Addendum / Addenda

Project Description / Description de projet M38 M38 Electrical Service		
Solicitation No./N° de sollicitation 17-22113	Project No./N° de projet 5310	W.O. No./N° d'ordre de travail A1-006442-01
Departmental Representative / représentant ministériel Allan Smith		Date January 15, 2018
Notice: This addendum shall form part of the tender documents and all conditions shall apply and be read in conjunction with the original plans and specifications.		Nota: Cet addenda fait partie intégrale des dossiers d'appel; toutes les conditions énoncées doivent être lues et appliquées en conjonction avec les plans et les devis originaux.

- 1 Included with this addendum are replacement drawings 5310-E01R, 5310-E02R, 5310-E03R to replace 5310-E01, 5310-E02 and 5310-E03.
- 2 A question was raised regarding the size of the transformer secondary wiring. It is to be 3 x (4 #350+GND RWU90). Cable spec as below:

drawing: **PARTIAL SITE PLAN AND CABLE ROUTE THROUGH M-36** dessin

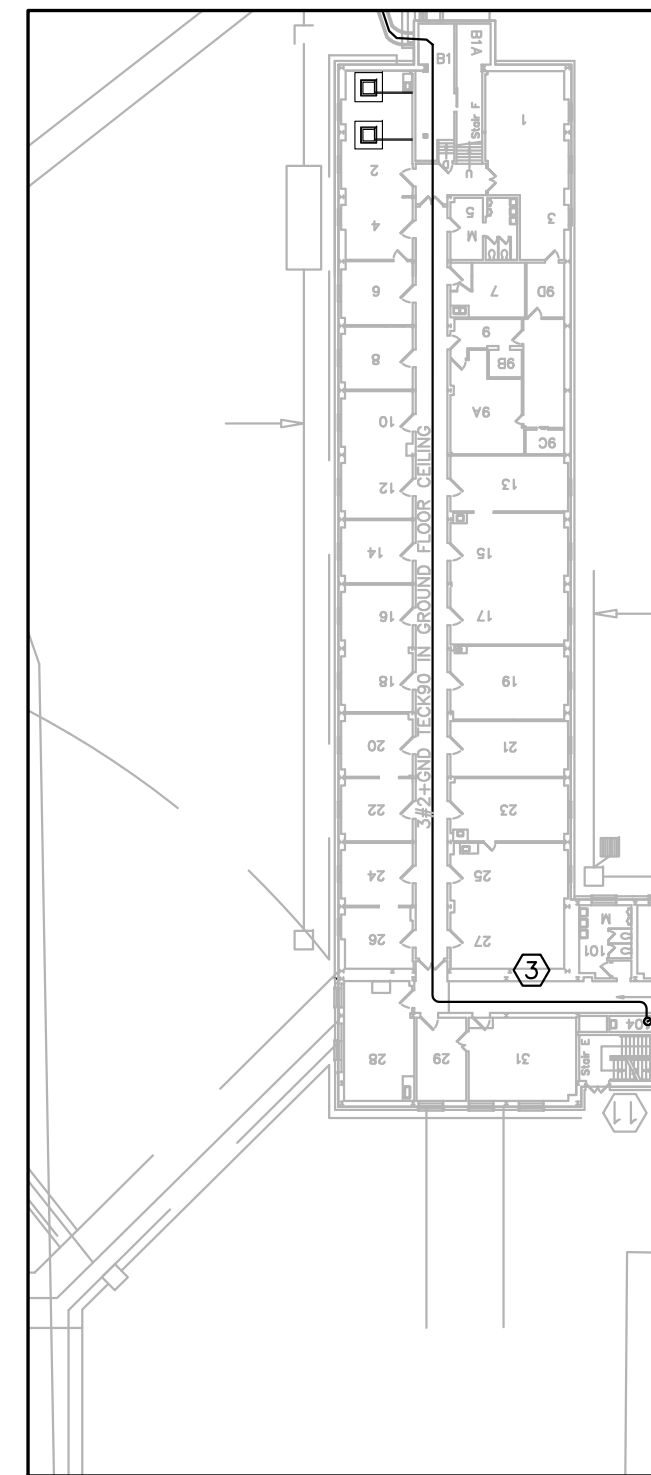
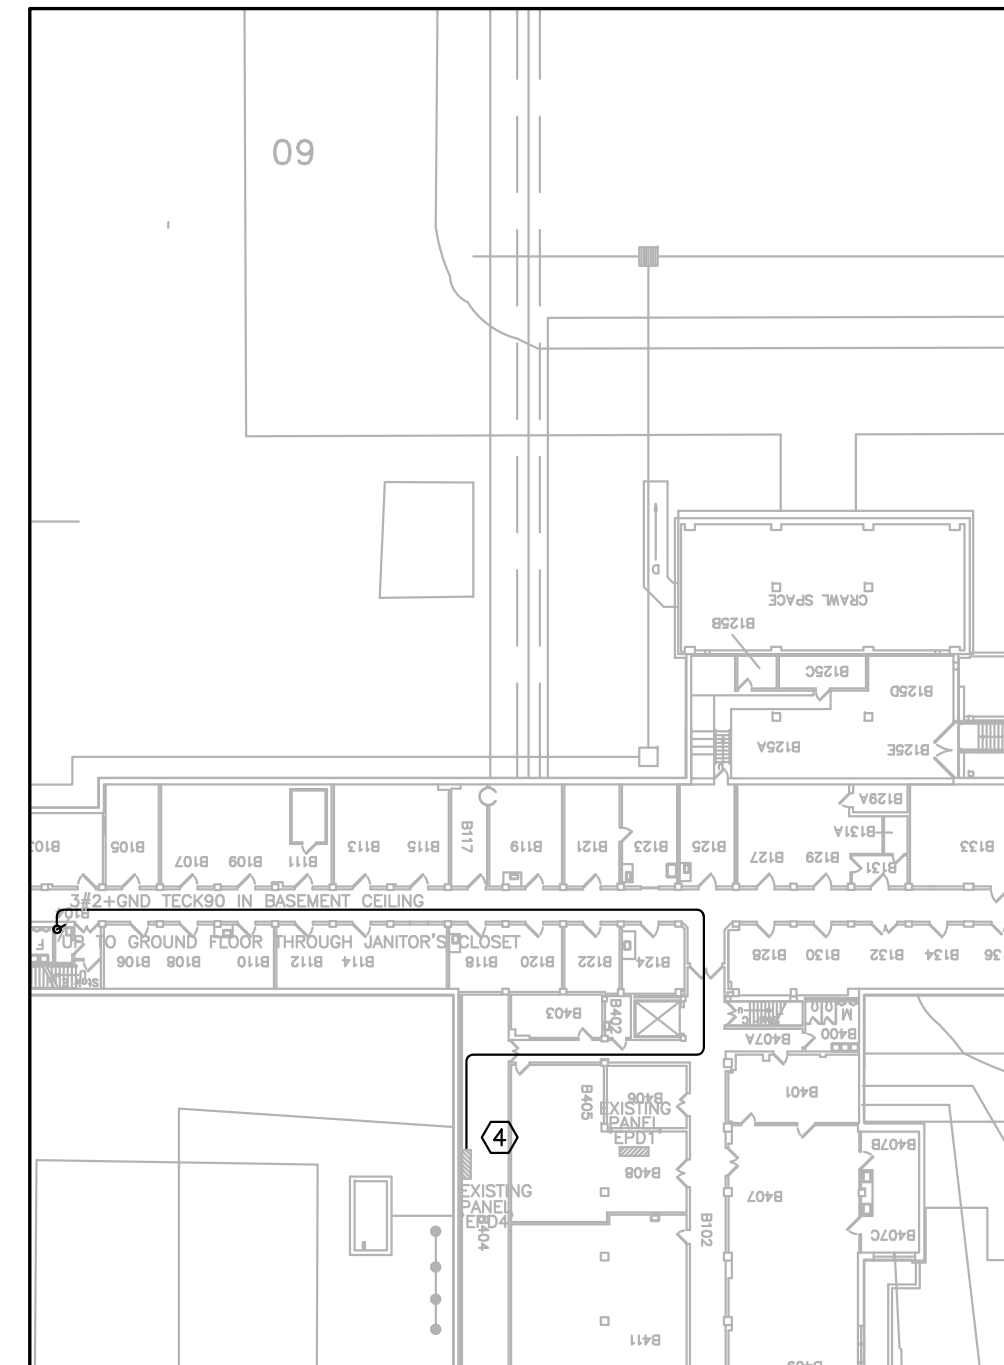
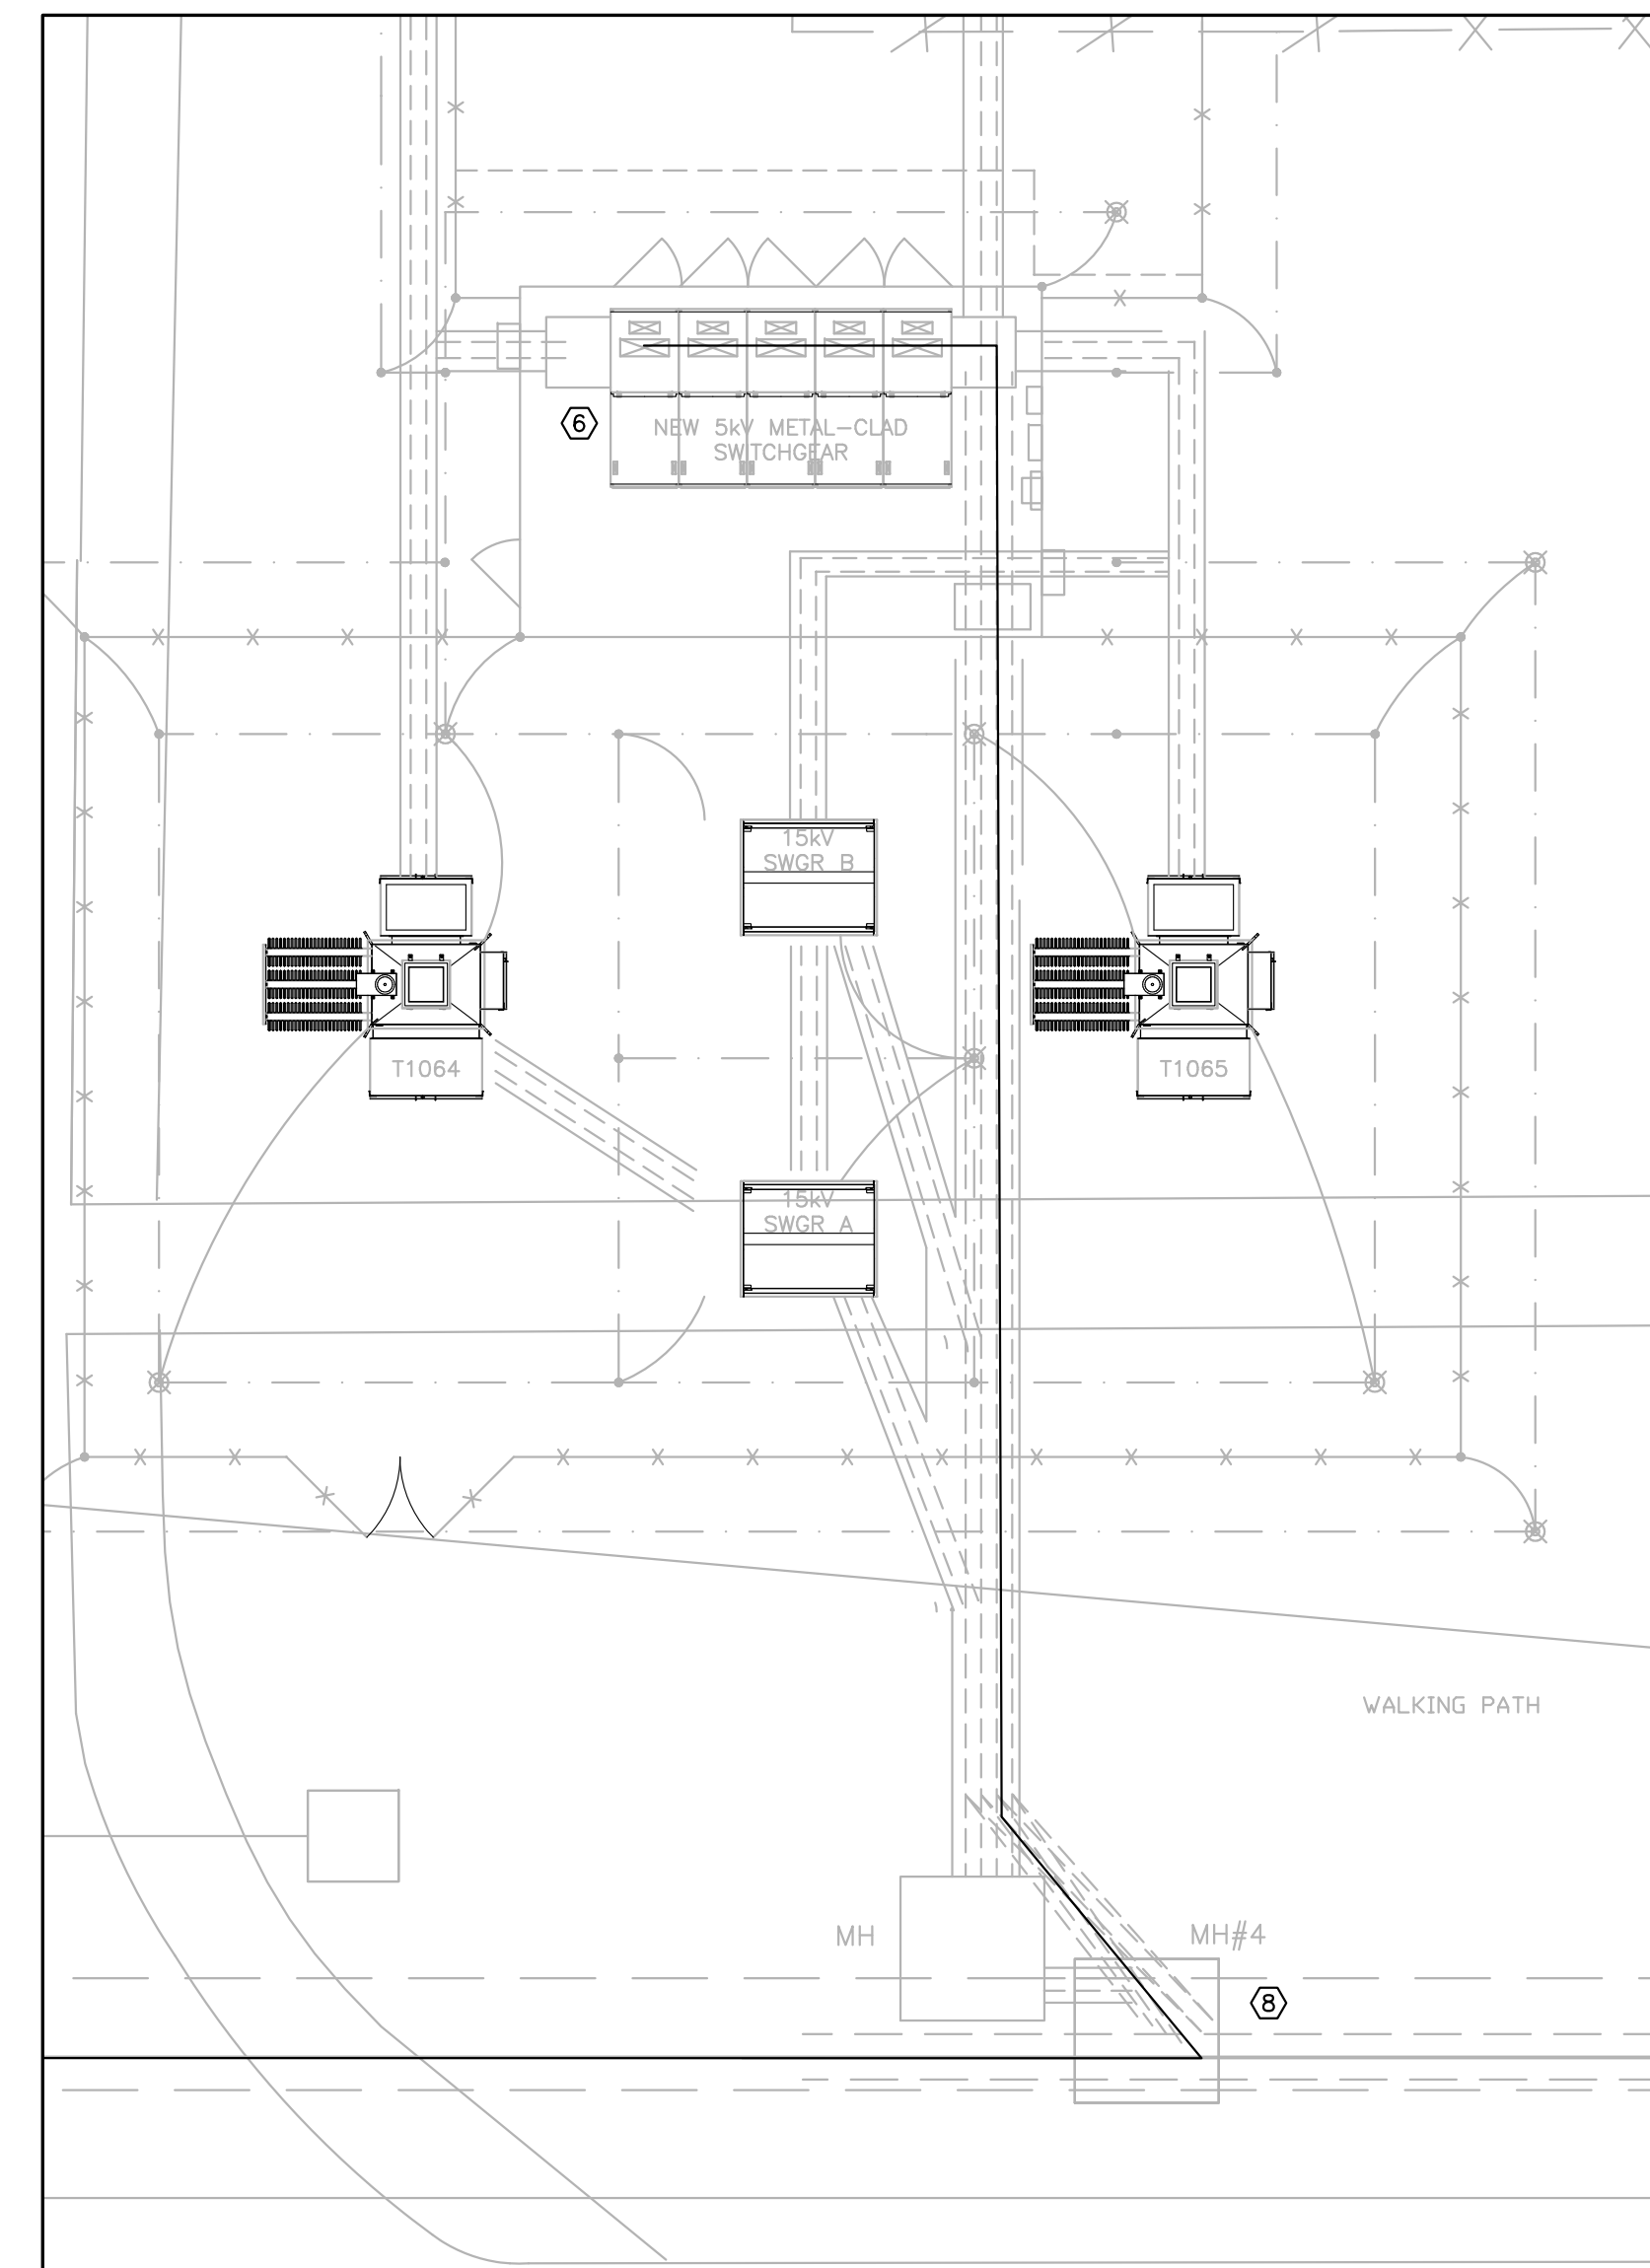
- 8 Emergency power to be fed from panel "EPD4' in room B404 instead. Cable to be surface mounted in room B404 and run into corridor directly. The rest cable routing to follow existing shown on the drawing.

drawing: **M-46A SINGLELINE** dessin: _____

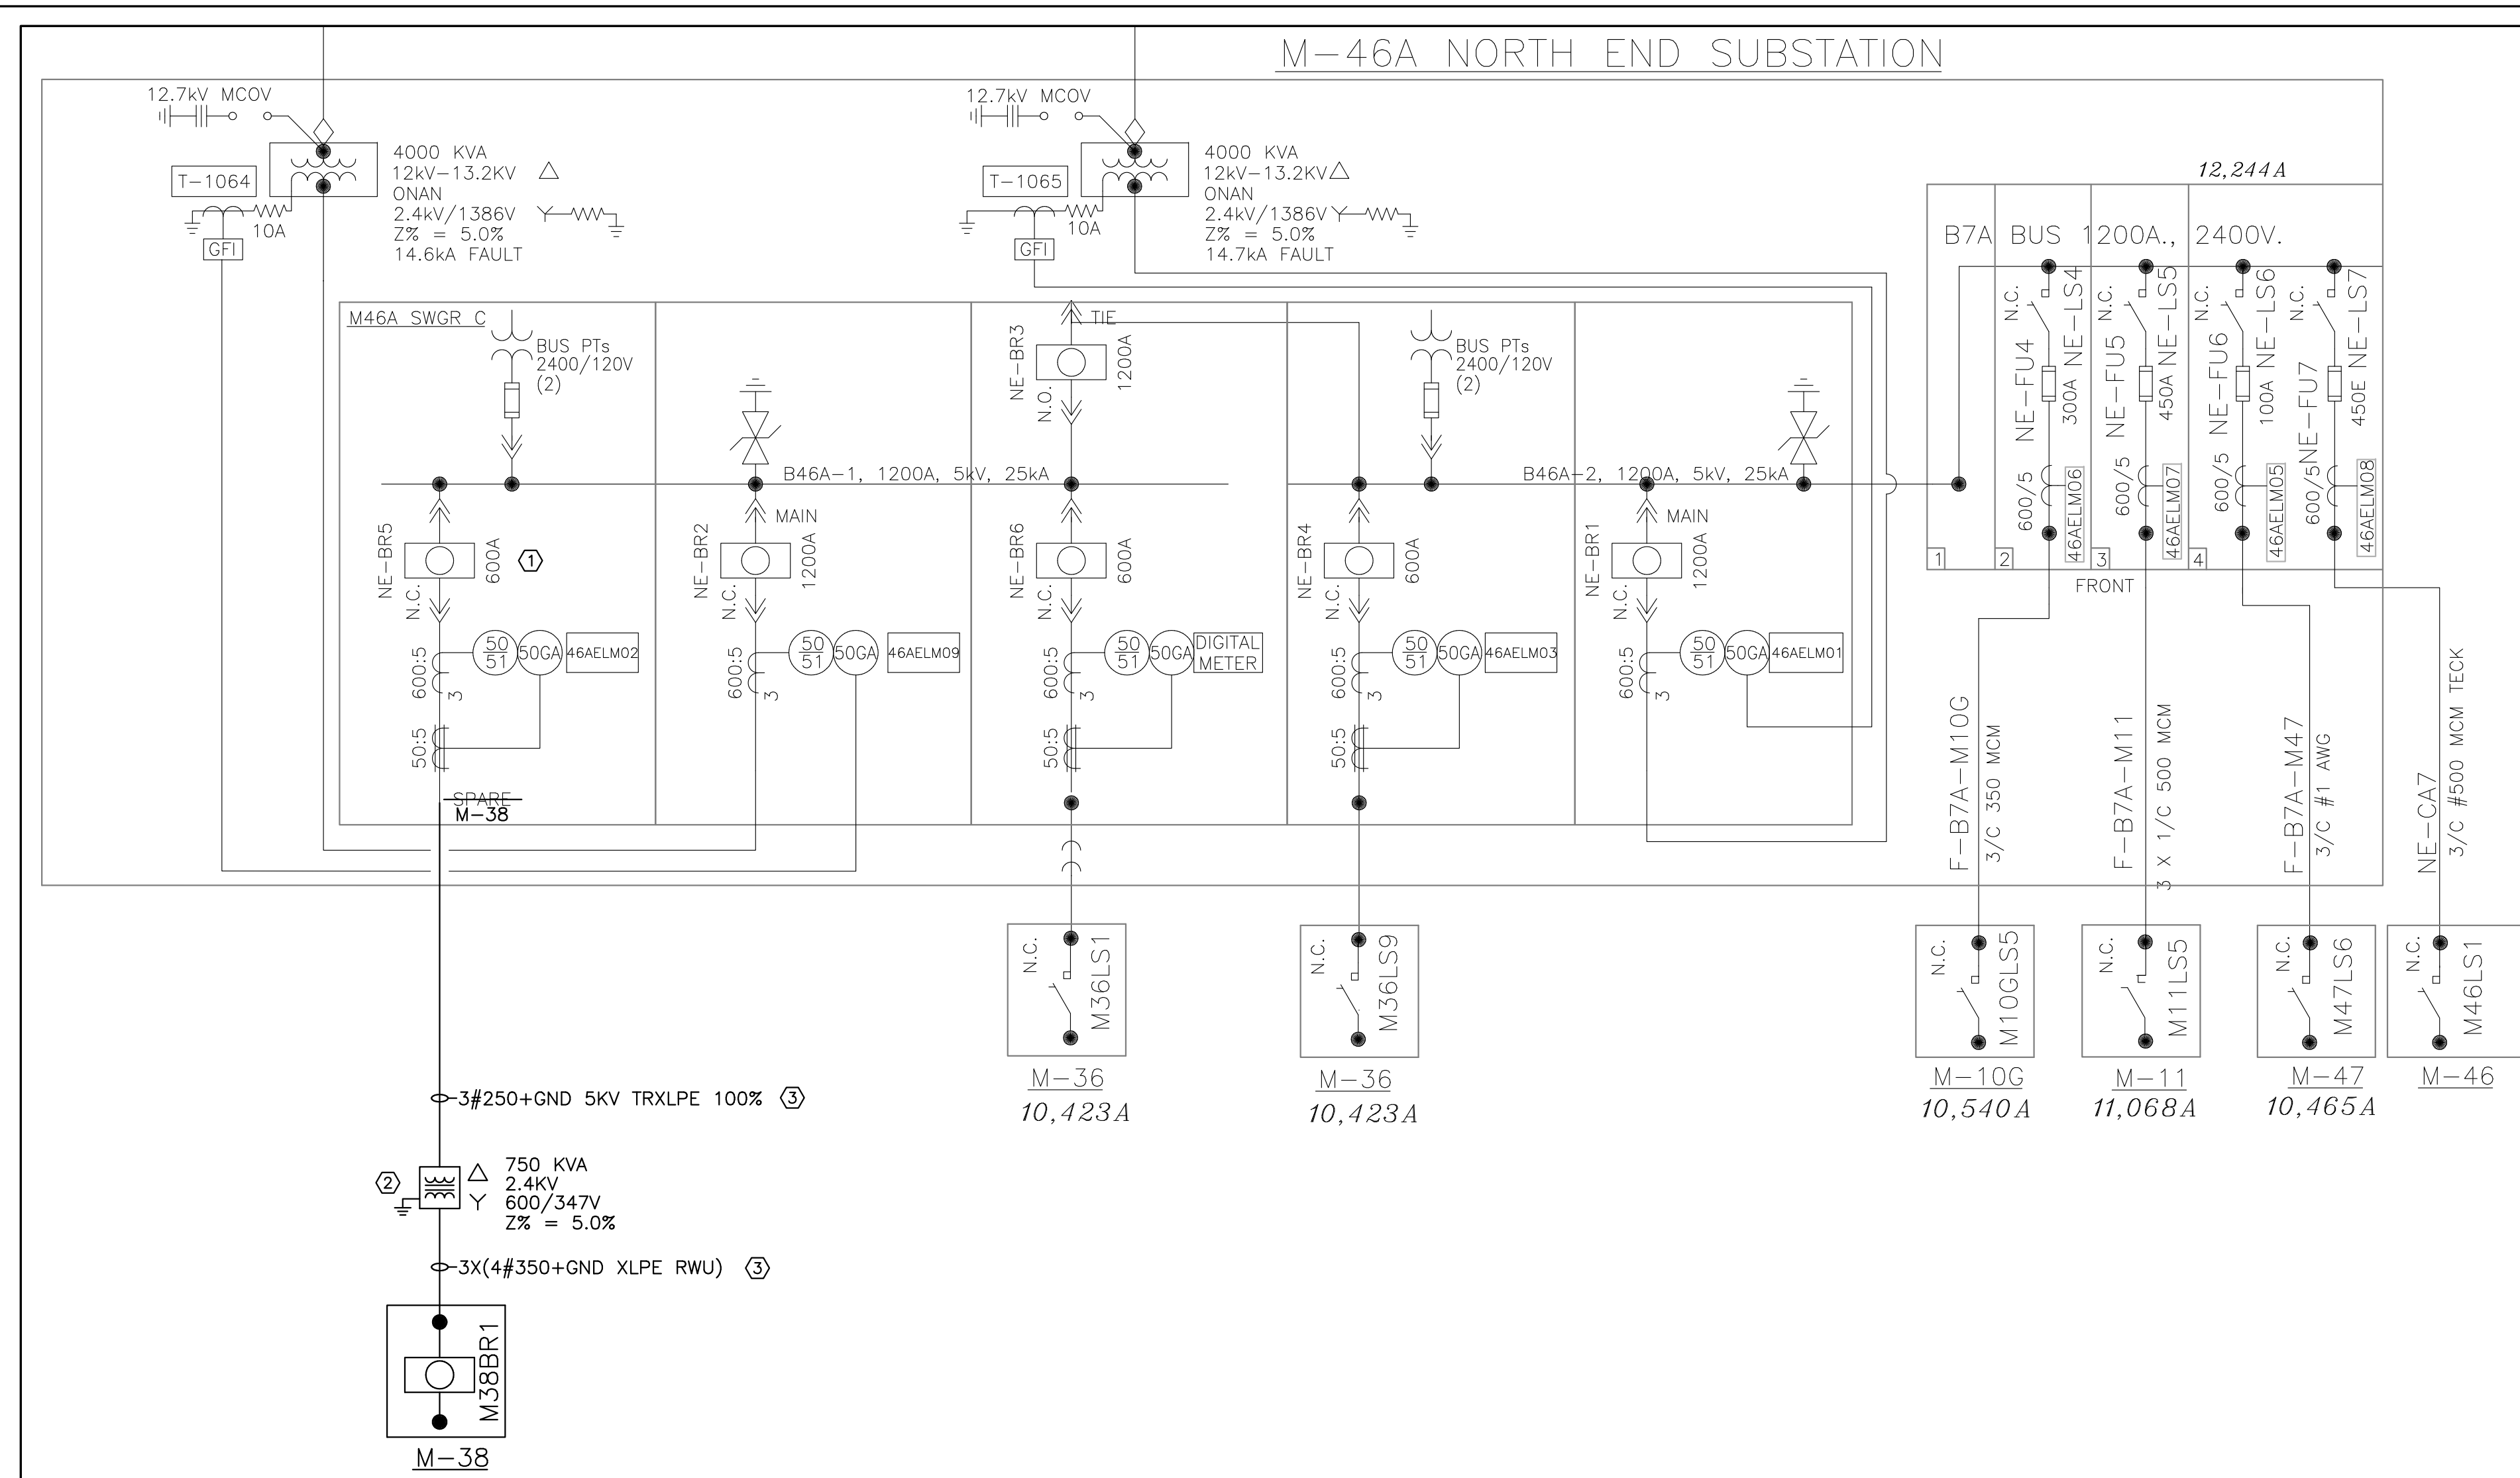
- 5 5KV TRXLPE cable to be unarmoured but shielded. Spec as below:
 - .1 Single copper conductor, Class B stranded, size as indicated.
 - .2 Semi-conducting crosslinked polyolefin conductor shield.
